National Committee on Uniform Traffic Control Devices

Markings No. 1

TECHNICAL COMMITTEE:	Markings
TOPIC:	Crosswalk Markings
STATUS:	Approved by Markings, January 2011 Distributed as sponsor ballot, Spring 2011
ORIGIN OF REQUEST:	FHWA high visibility crosswalk marking study
AFFECTED PORTIONS OF MUTCD:	Section 3B.18

Figure 3B-17. Examples of Yield Lines at Unsignalized Midblock Crosswalks
 [Figure revised by adding longitudinal markings to crosswalks]

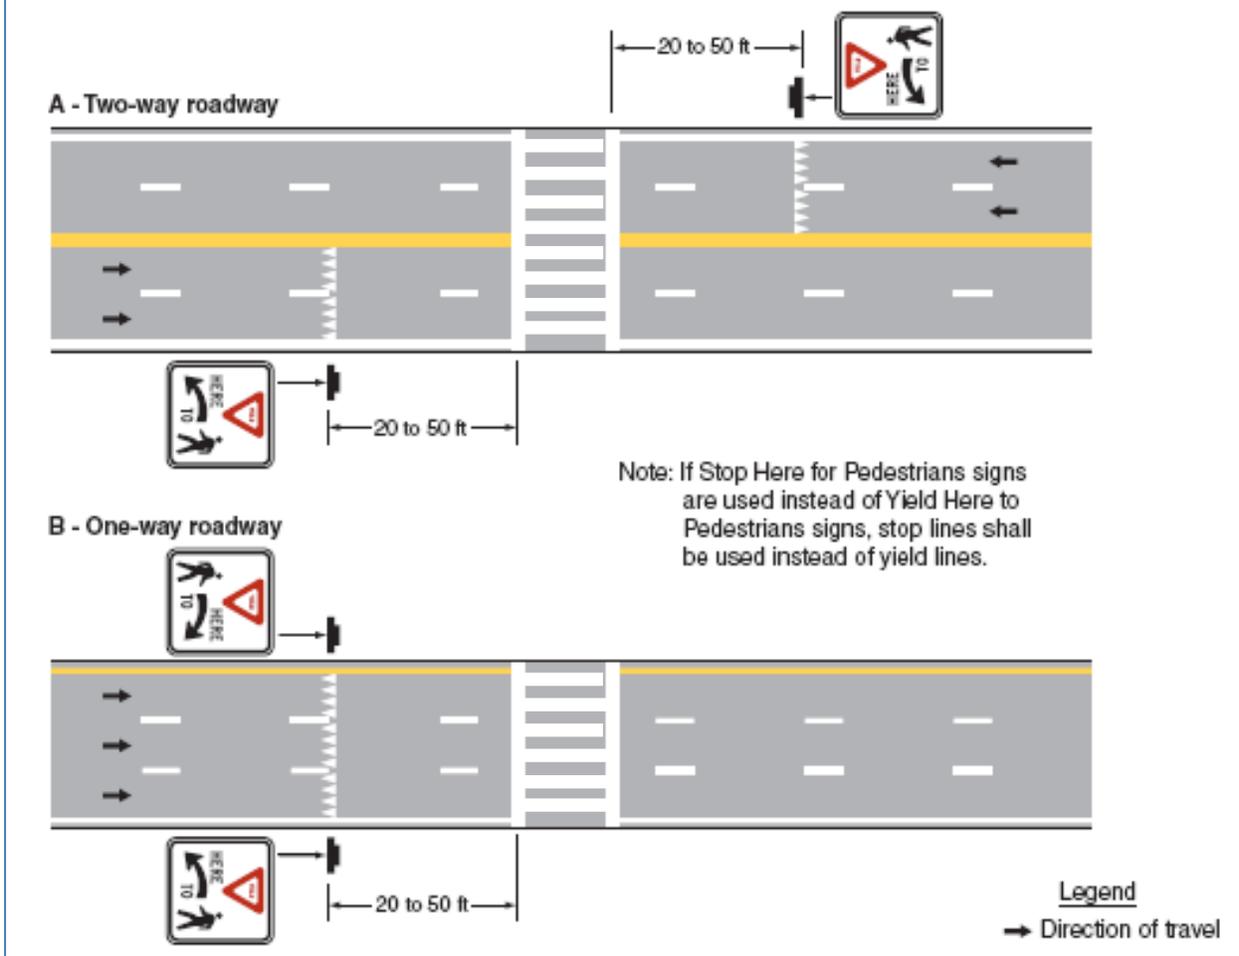
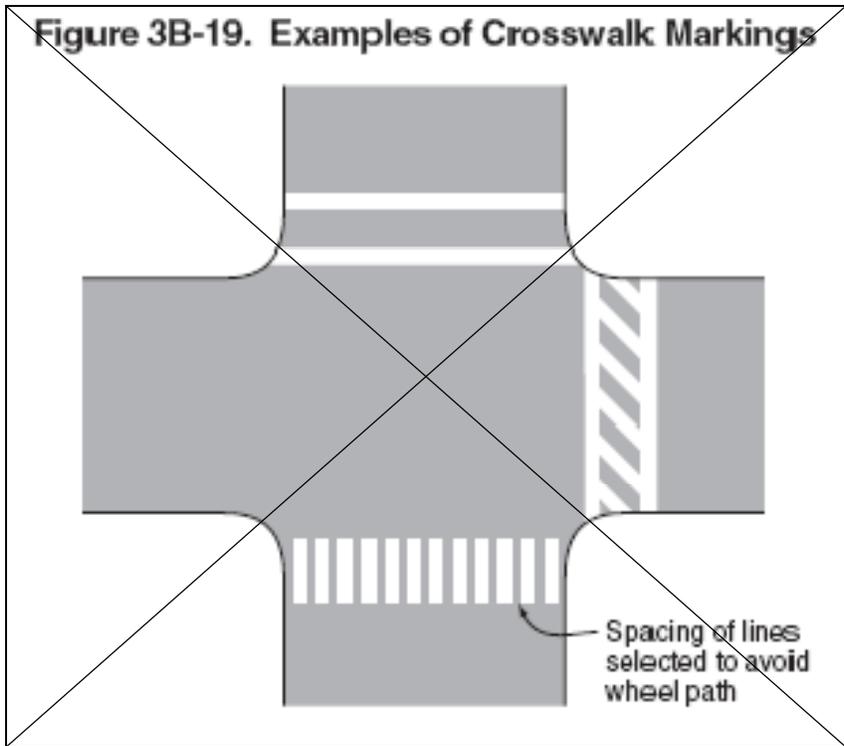
104-109 (¶ 15)	<ul style="list-style-type: none"> • Text added to provide guidance on dimensions, especially for bar pairs.
130-131 Fig 3B-17	<ul style="list-style-type: none"> • Figure 3B-17 has been revised to a high-visibility crosswalk marking pattern instead of a basic crosswalk marking pattern.
134 Fig 3B-19	<ul style="list-style-type: none"> • Existing Figure 3B-19 replaced with new Figure 3B-19

Figure 3B-19. Examples of Crosswalk Markings
[New Figure 3B-19 to replace existing figure]

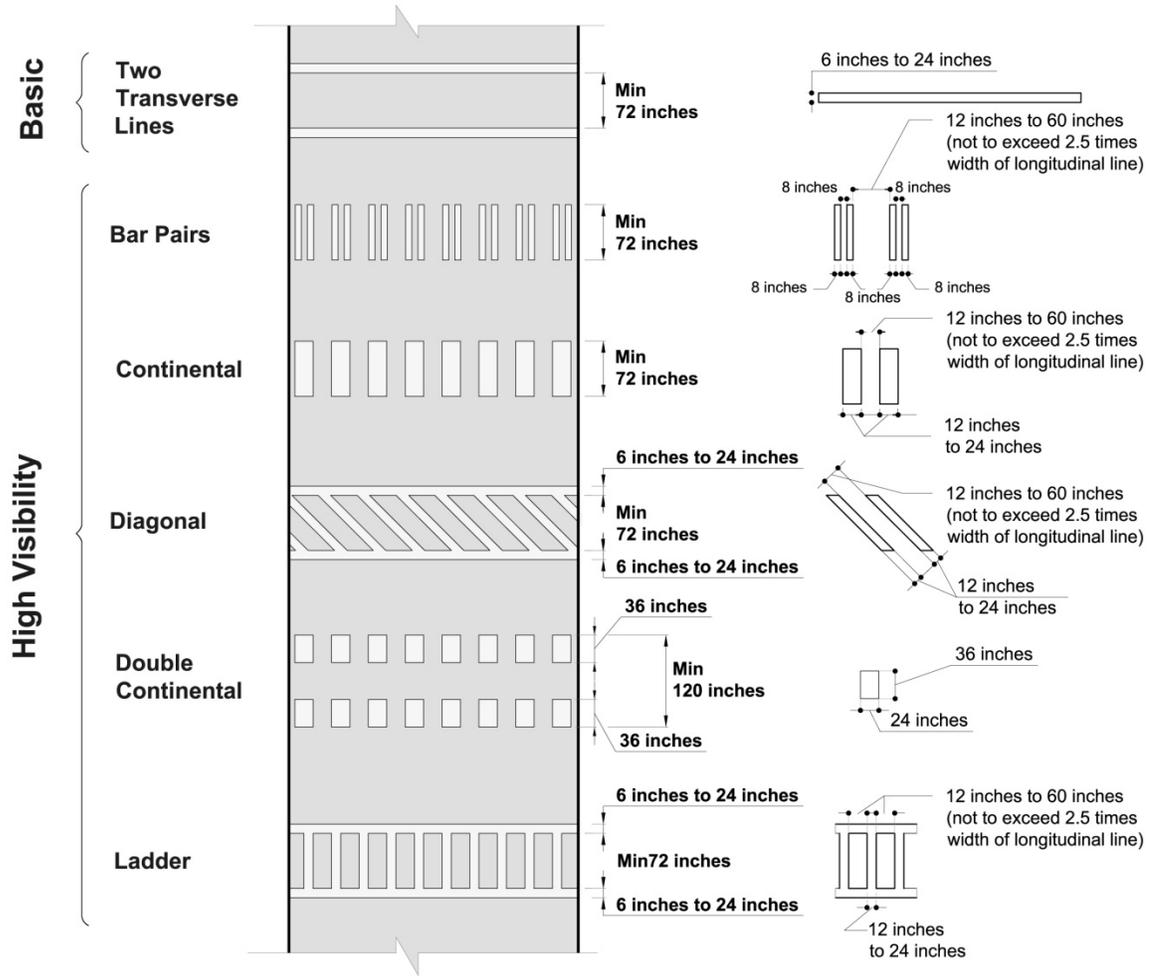
[Existing Figure 3B-19 replaced with new Figure 3B-19 on next page]

19 04.1 Crosswalk markings are classified as basic or high visibility. Basic crosswalk markings
20 consist of two transverse lines. High visibility markings consist of diagonal or longitudinal lines
21 parallel to traffic flow with or without transverse lines. Figure 3B-19 presents examples of
22 crosswalk markings. [note: Figure 3B-19 has been revised]
